**MUNICIPAL PLANNING COMMISSION AGENDA  
SUMMER VILLAGE OF NORGLLENWOLD  
SUMMER VILLAGES ADMINISTRATION OFFICE  
SEPTEMBER 24, 2021 @ 12:30 P.M.**

**Summer Village of Norglenwold – Municipal Planning Commission****September 24, 2021****Agenda Item****23 Grand Avenue (Lot 1&2, Block 2, Plan 5116AE)****Development Permit Application****Background:**

**Re: Tall Wall Framing Review – 23 Grand Avenue Garage, Norglewold, Alberta**

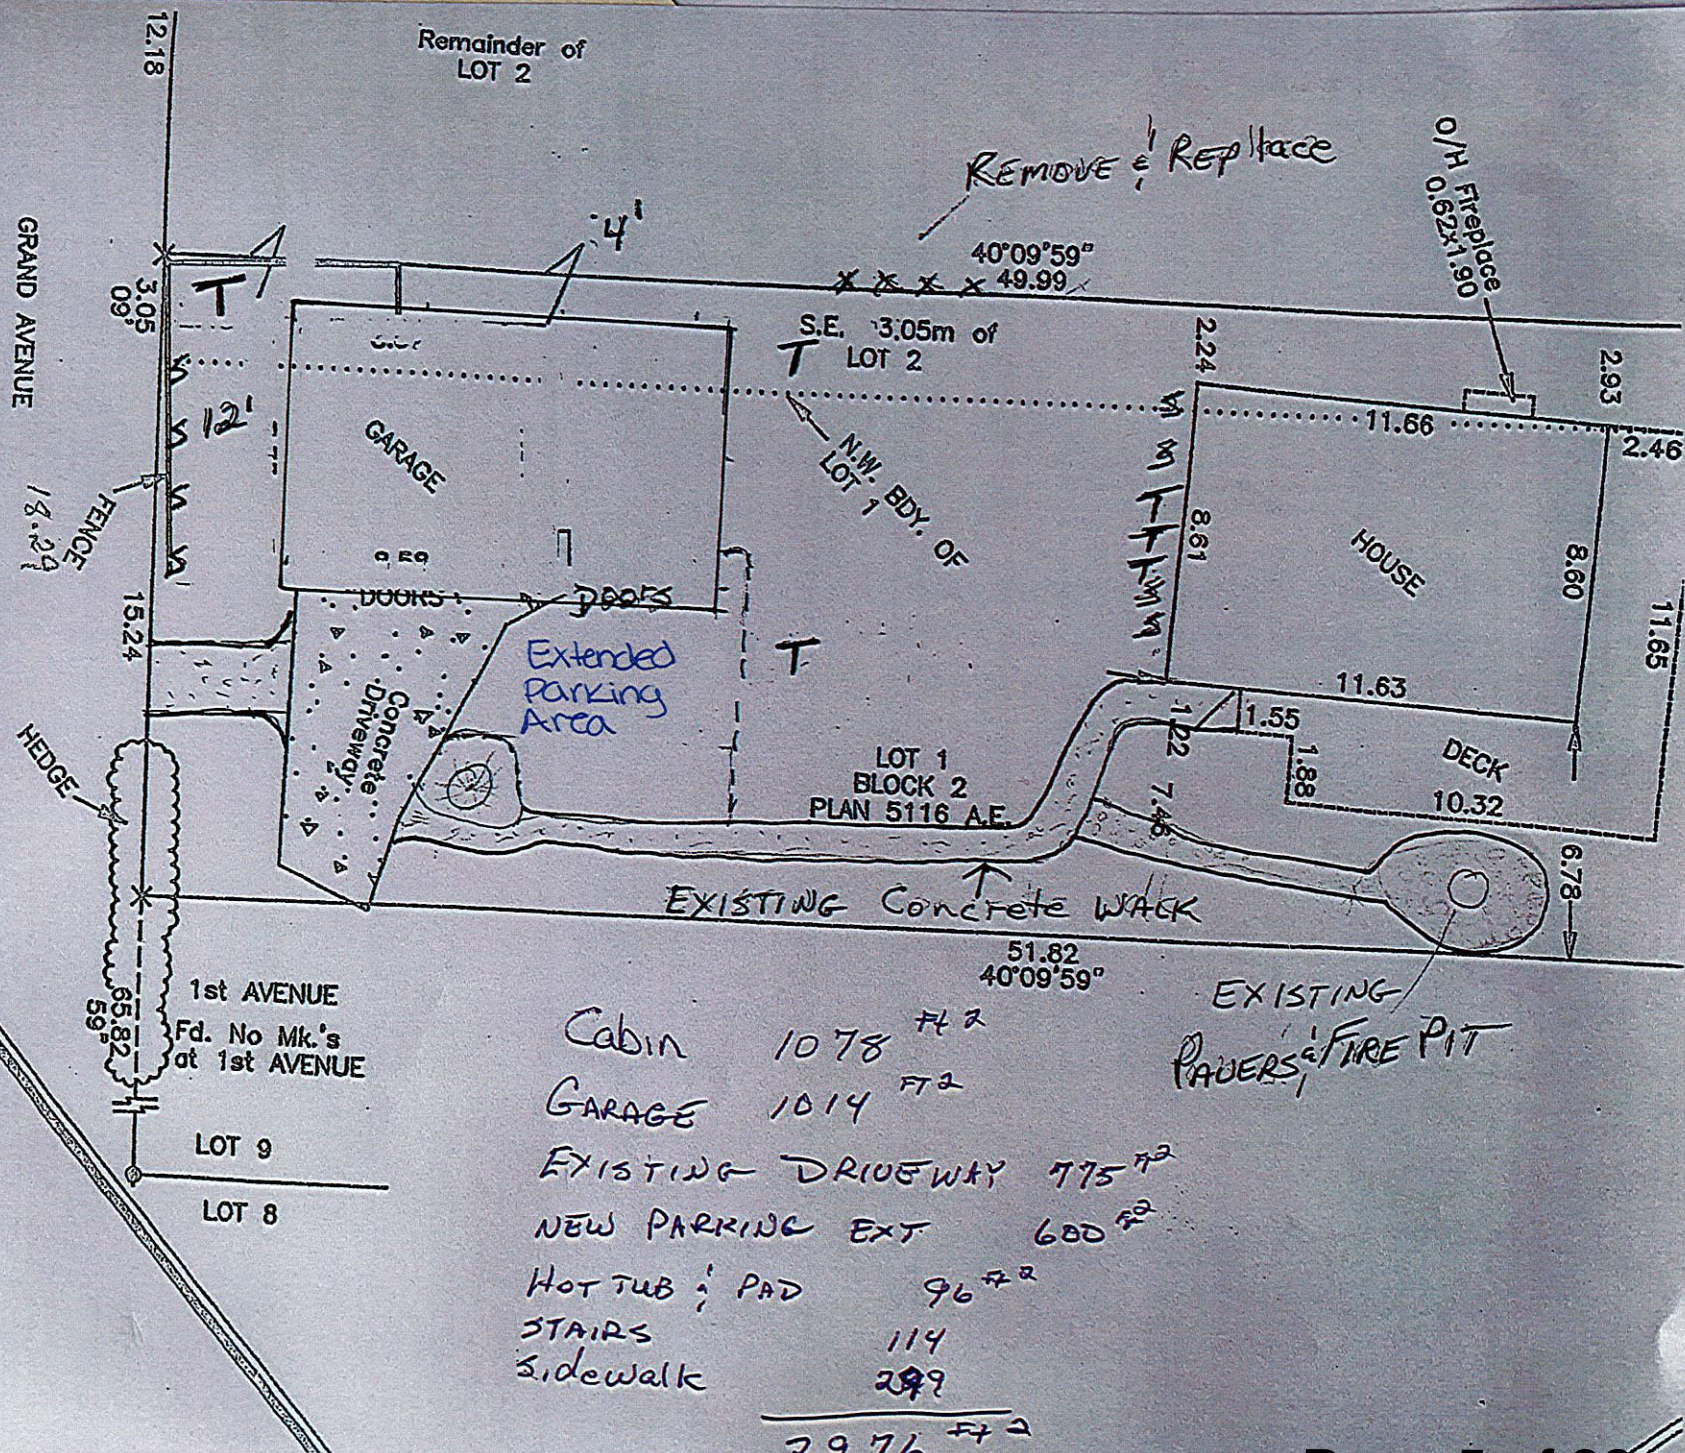
I would like to amend our Demolition permit, to include the construction of a 26' x 39' Accessory Building / Detached Garage. The existing use was a 24' x 28' Accessory Building / Detached Garage. We cut the concrete back from the door side of the garage to facilitate the installation of the new foundation, and to retain the original grade and the continued use of the existing driveway. We will need to extend the parking area toward the dwelling as we will be moving the new garage 11 feet into the yard to allow for the minimum rear yard of 12' for a side entry garage. In addition we will be increasing the side yard setback to 4' to account for the 2' eave on the rear of the garage. The new garage is 15' in height on the door side and slopes to 9' on the rear side. I believe this meets all the LUB requirements except for the size which is 14 sq. ft. over the maximum allowable.

During the demolition process we had indicated that we would be removing 4 trees and twenty feet of hedge, when in fact we had to remove 6 trees. All 6 will be replaced as indicated on our landscape plan. the hedge will be replaced with shrubs as indicated.

### FRONT ELEVATION

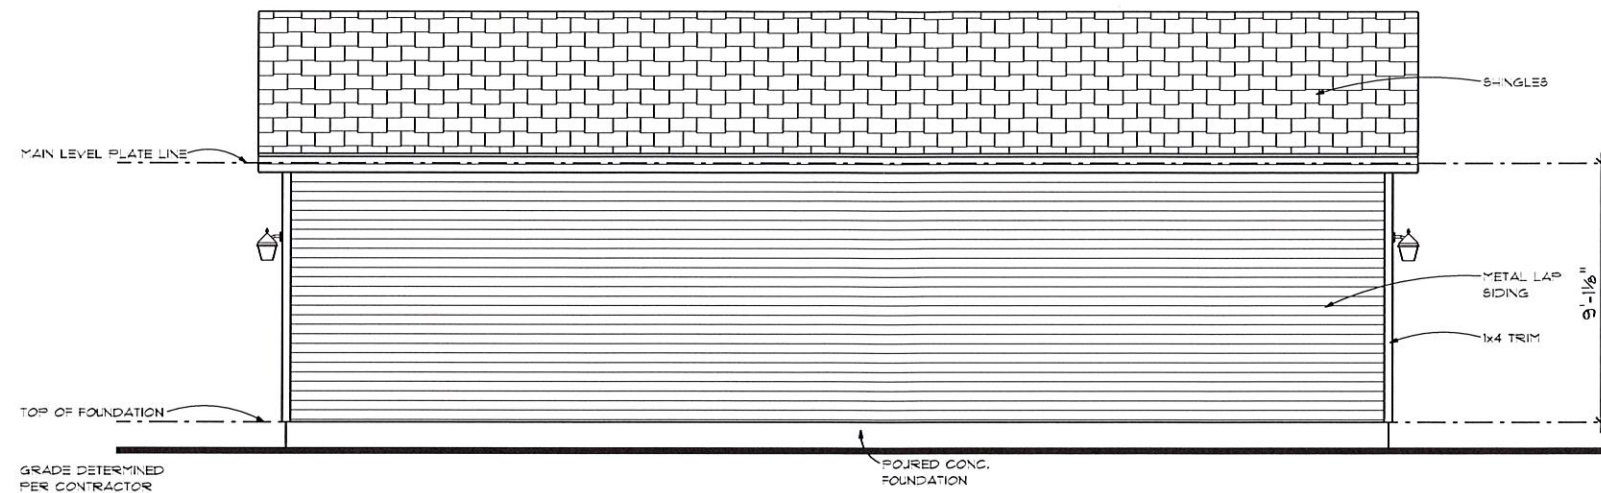
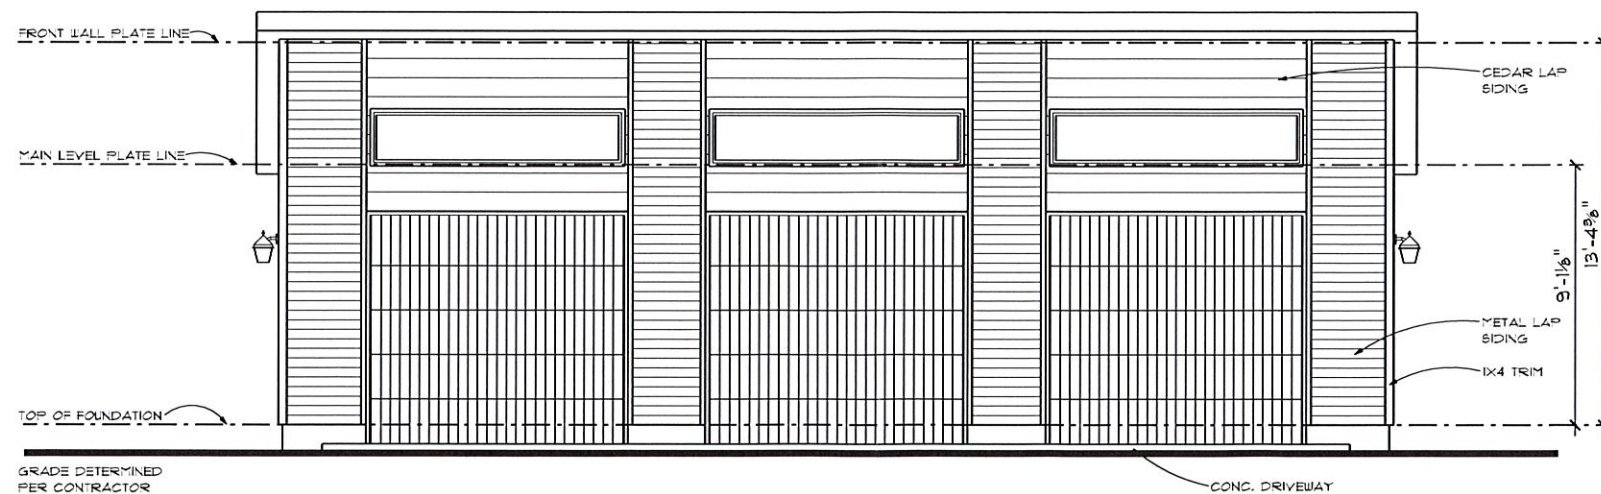
The tall wall elements are generally limited to the front façade which is dominated by the three (3) overhead doors, but small portions of the two side walls also apply. The plans note the stud walls as being 2x6 @ 16" o/c – which will not suffice for the tall wall sections. Instead, they should be doubled 2x6 @ 16" o/c for the front wall, and 2x6 @ 12" o/c for the side wall sections that are above 11'-10" tall. The remainder of the walls will work fine as 2x6 @ 16" o/c. All four walls should have mid-height blocking however (max. 6' o/c).

In addition, the overhead door openings should be formed with five (5) ply 2x6s on each side, two (2) of which are cripple studs set below the lintel beams, with the other three (3) being full height members. The lintel beams to span the nominal 9'-3" wide door openings, should be either 2-ply 1.75"x9.5" 2.0E LVLs, or 3-ply 2x12 No1/2 grade SPF. 3-ply 2x10s have the bending strength needed, but may deflect a bit more than desired.
